MEMORANDUM

Re: Work Session for the Exchange Planned Development and Conditional Building and Site Design Review at 320 E 400 South (PLNSUB2018-00434 & PLNPCM2018-00470)

ACTION REQUIRED: Discuss the proposed development and identify any issues or concerns with the applicant's current plans as they relate to the applicable standards.

- ***Ground Floor Use – Blair Street***

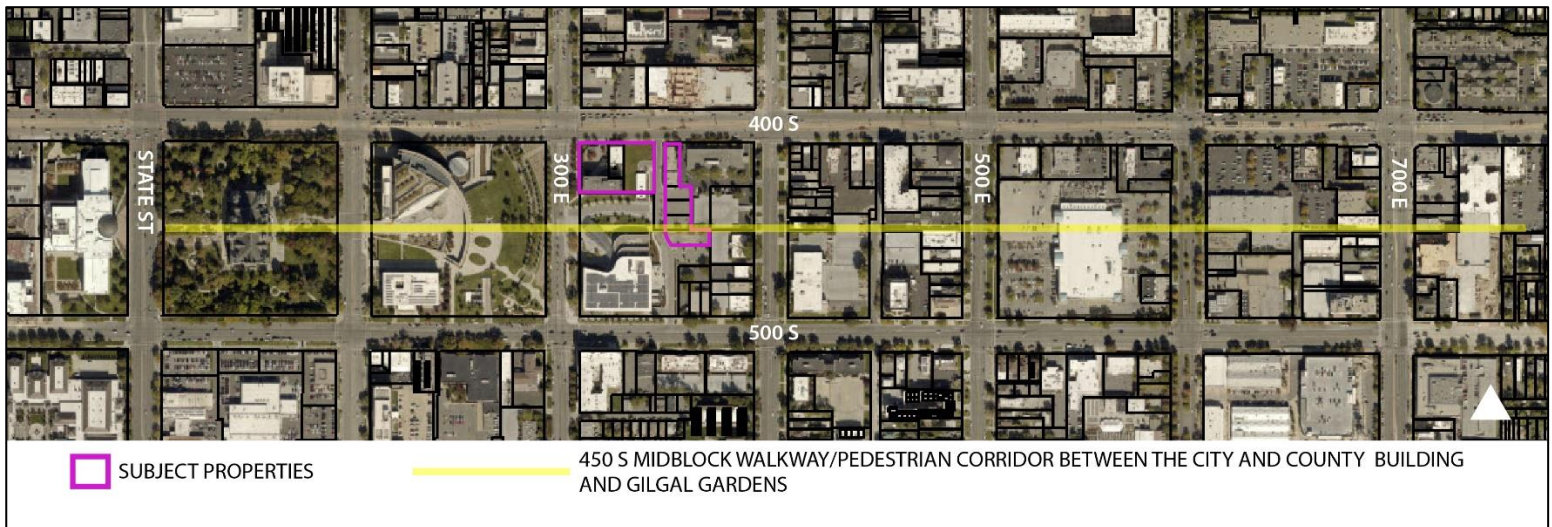
The ground floor of Building B is primarily parking along Blair Street, and the design of the building reflects the proposed use. Staff acknowledges that because of the dimensions of the site, locations to incorporate parking for the development are limited, however the applicant still needs to demonstrate how the requested modifications meet the intent of the design standards which is to activate the streetscape. As currently proposed, Staff is of the opinion the requested reductions to ground floor active use and visual interest requirements paired with the proposed increased façade length, which is almost twice as long as the maximum 200 feet allowed in the zoning ordinance, do not meet the intent of this design standard. Approximately 100 feet of the south end of this building has some visually interesting art and architectural features, however, those elements are not continued along the remaining 278 feet of street facing façade. Staff has offered some ideas including interactive lighting features, or looking at the possibility of reorienting the proposed bike parking so it fronts on Blair St. and maybe adding a fix it station as opposed to having pedestrians traveling along Blair Street look directly in on parking stalls. Additional ideas should be explored by the applicant for the Blair Street ground floor elevation to demonstrate how the project meets the intent of providing active ground floor uses and visual interest at the pedestrian level.

GROUND FLOOR USE AND VISUAL INTEREST(BLAIR STREET)
 25'-0" DEEP GROUND FLOOR USE IS ACHIEVED AT RETAIL = APPROX. 15% OF THE FACADE (31'-0"/199'-0")

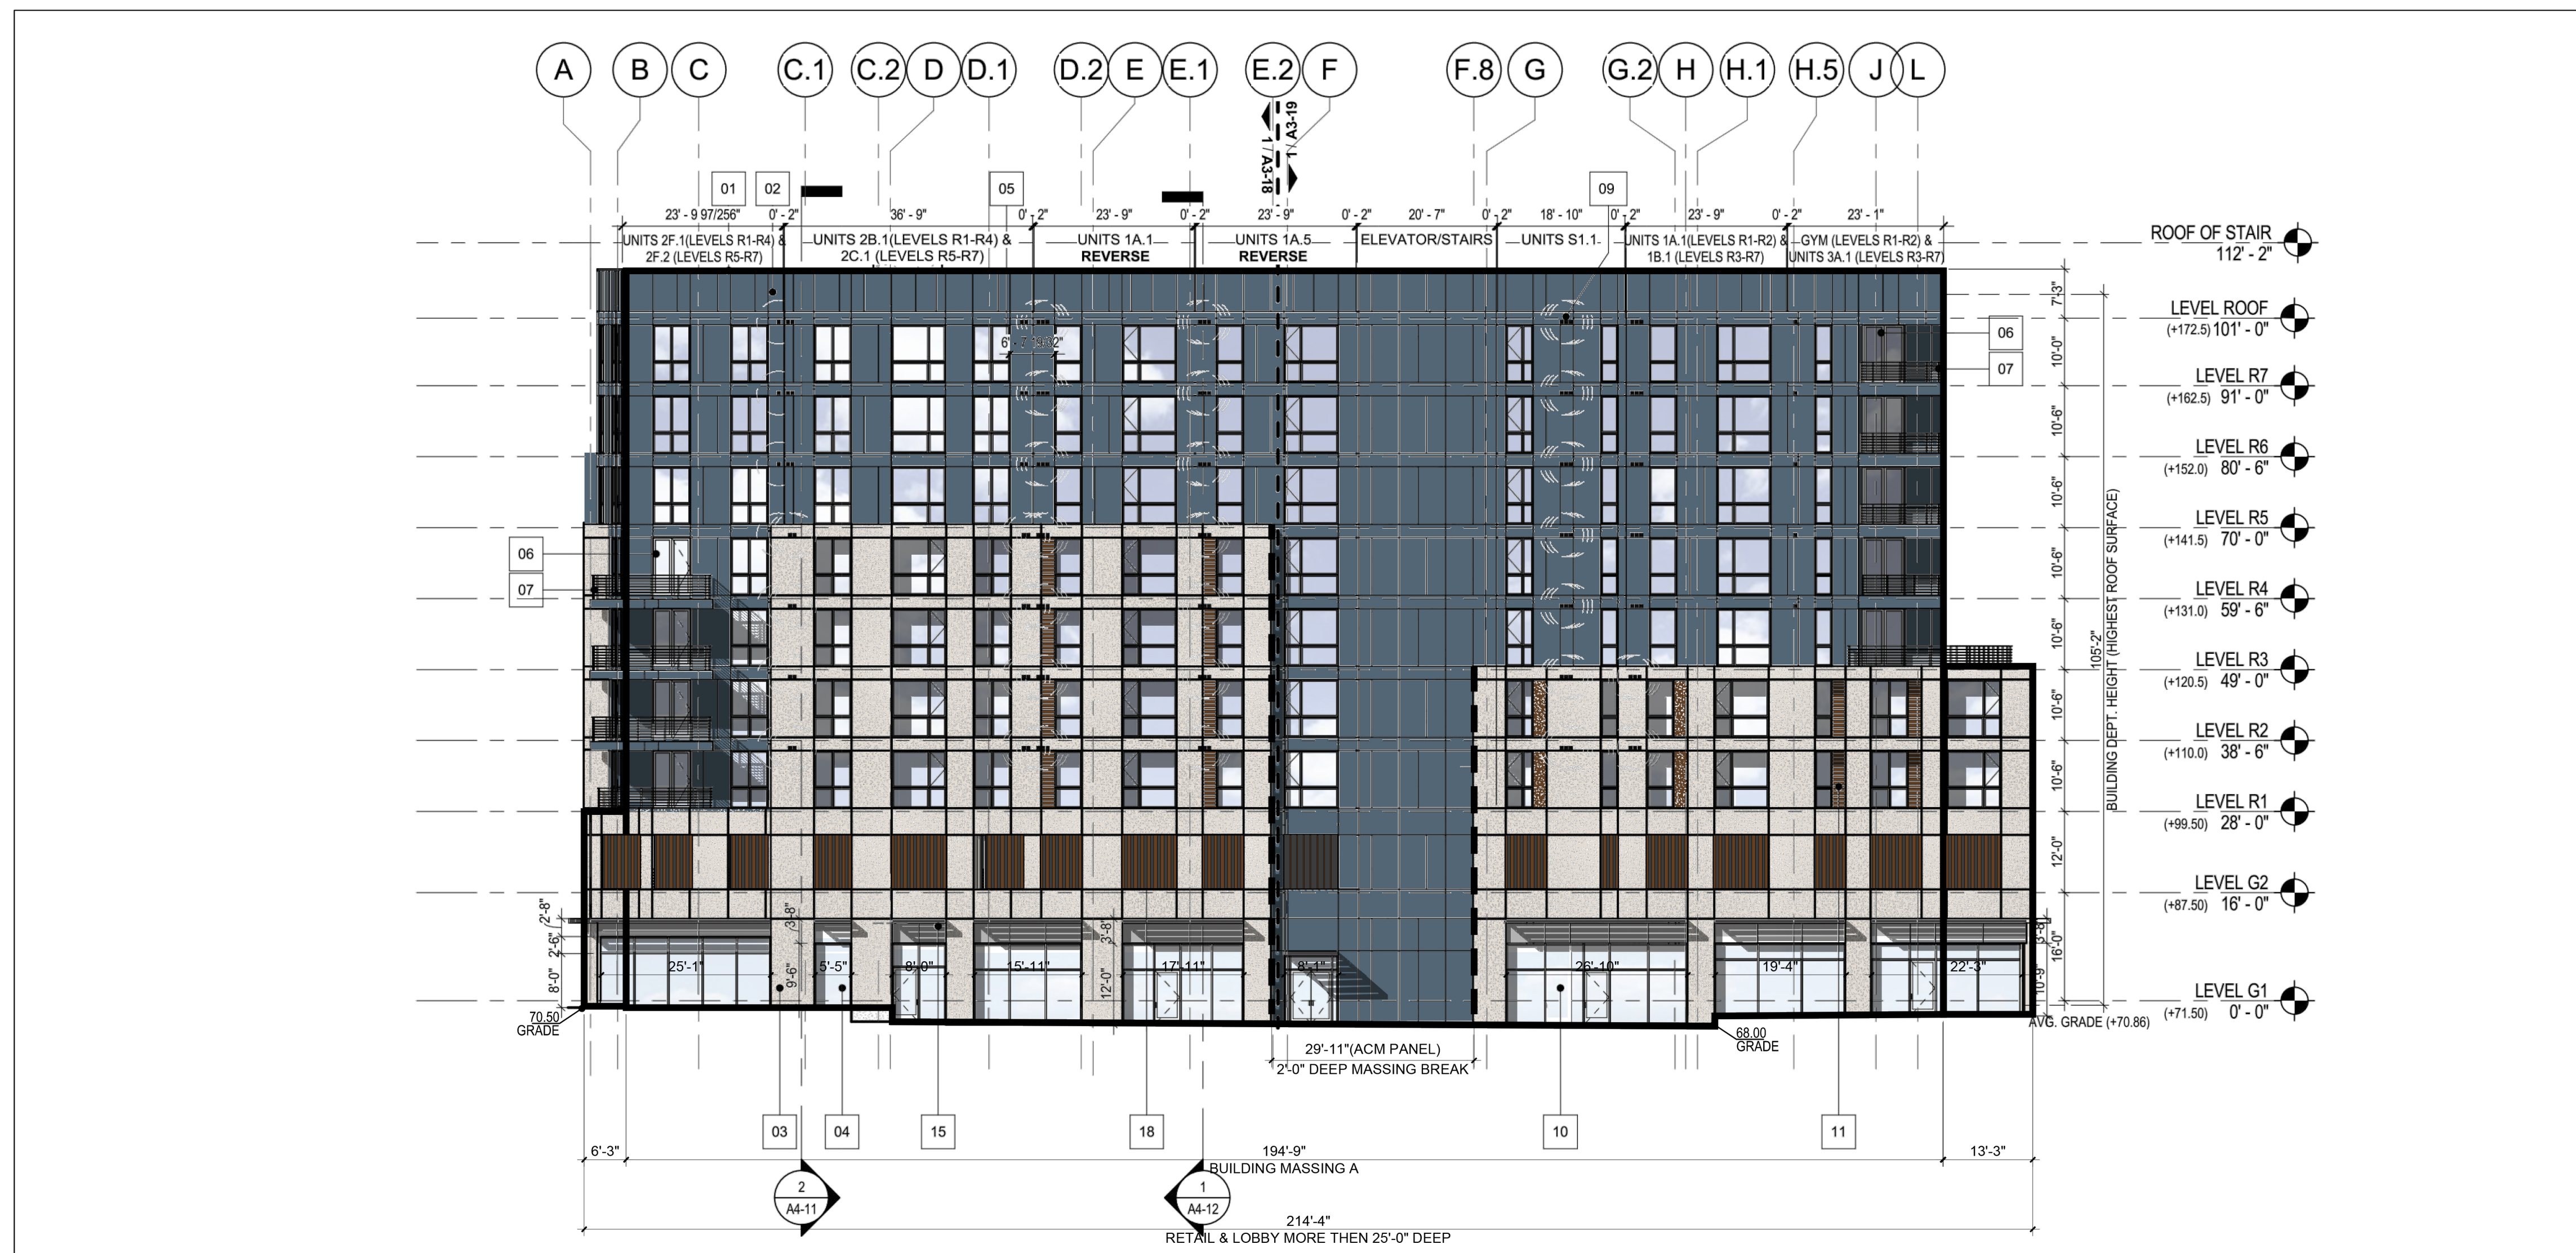
Because a large portion of the ground floor use along Blair Street is proposed as parking, the applicant is requesting a reduction of operable building entrances which are required every 40 feet. The proposed length of the Blair Street façade is approximately 378 feet and therefore required to have 9 operable building entrances. There are 3 building entrances proposed on Blair Street and Staff is of the opinion the entrances that are provided are rather discrete and appear more like service entrances and could be better defined with a greater level of architectural detail or more prominent entry feature. The applicant will need to provide more information with their proposal to demonstrate how the intent of this design standard is being met.
